Form 3160-5
(June 2019)UNITED STATES
DEPARTMENT OF THE INTERIOR
BUREAU OF LAND MANAGEMENTFORM APPROVED
OMB No. 1004-0137
Expires: October 31, 2021**SUNDRY NOTICES AND REPORTS ON WELLS**
Do not use this form for proposals to drill or to re-enter an abandoned well. Use Form 3160-3 (APD) for such proposals.5. Lease Serial No. **NMNM108503**

8. Well Name and No. **ANTERO 14 FED COM/501H**9. API Well No. **30-025-50614**10. Field and Pool or Exploratory Area
Red Hills; Lower Bone Spring11. Country or Parish, State
LEA/NM**12. CHECK THE APPROPRIATE BOX(ES) TO INDICATE NATURE OF NOTICE, REPORT OR OTHER DATA**

EOG respectfully requests an amendment to our approved APD for this well to reflect the following changes:

Revised Permit Information 09/08/2022:

WELL LOCATION AND ACREAGE DEDICATION PLAT

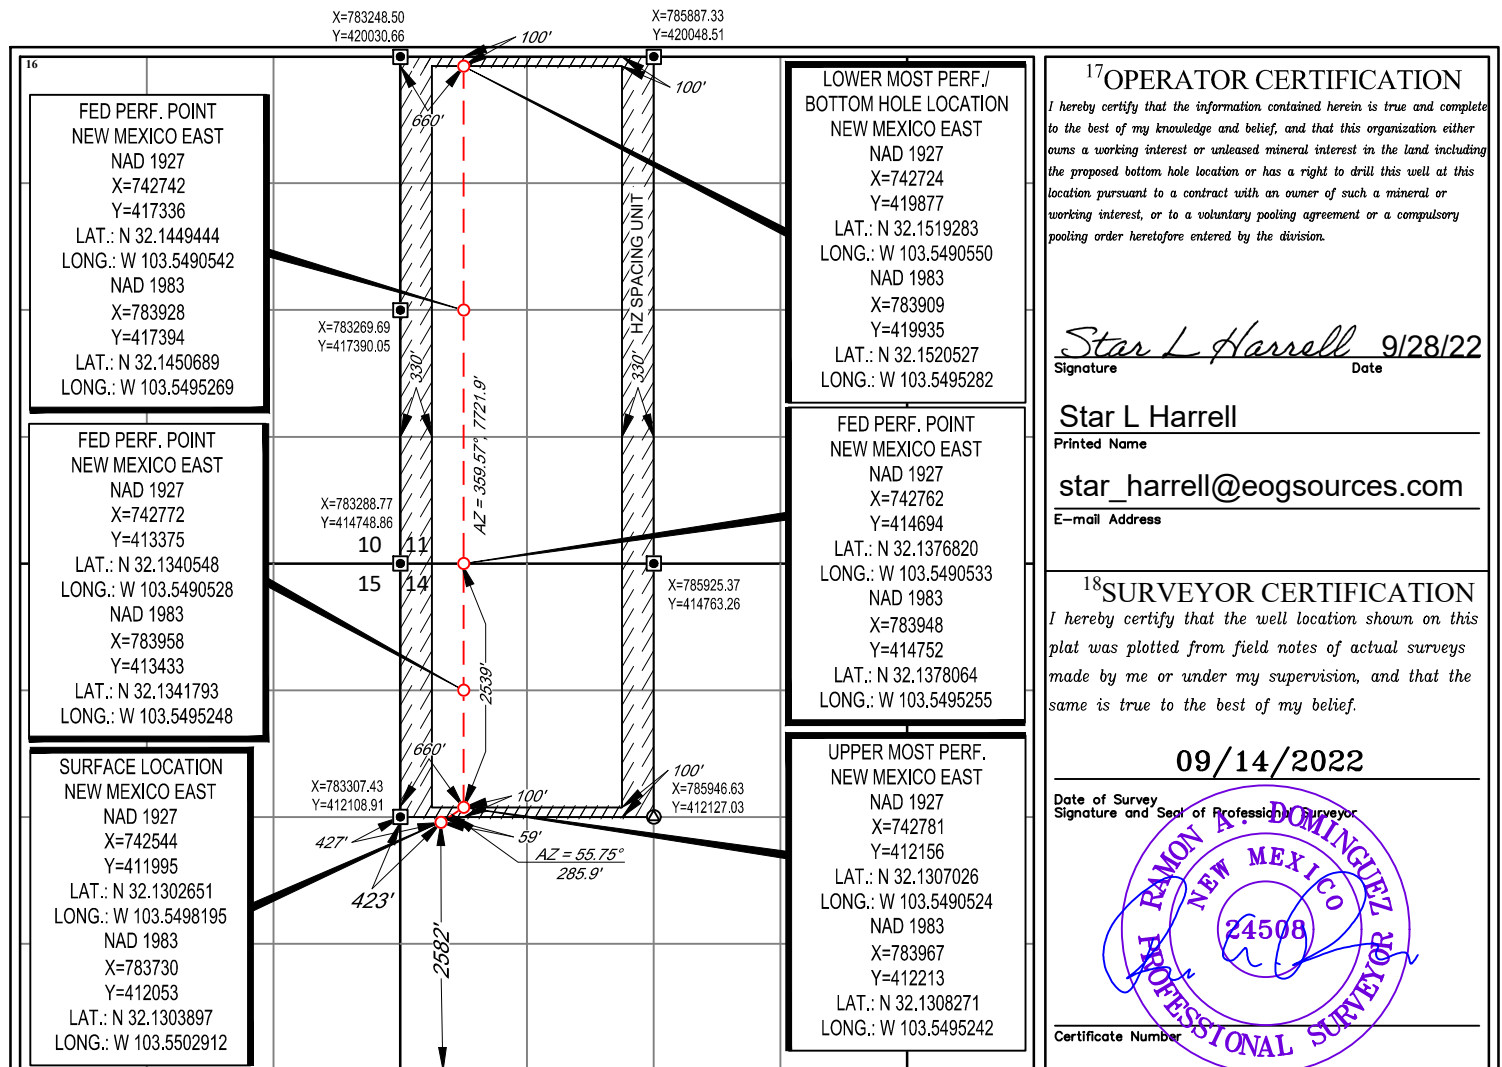
Change BHL from T-25-S, R-33-E, Sec 11, 100' FNL, 330' FWL, Lea Co., NM,
to T-25-S, R-33-E, Sec 11, 100' FNL, 660' FWL, Lea Co., N.M.

UL or lot no.	Section	Township	Range	Lot Idn	Feet from the	North/South line	Feet from the	East/West line	County
D	11	25-S	33-E	-	100'	NORTH	660'	WEST	LEA
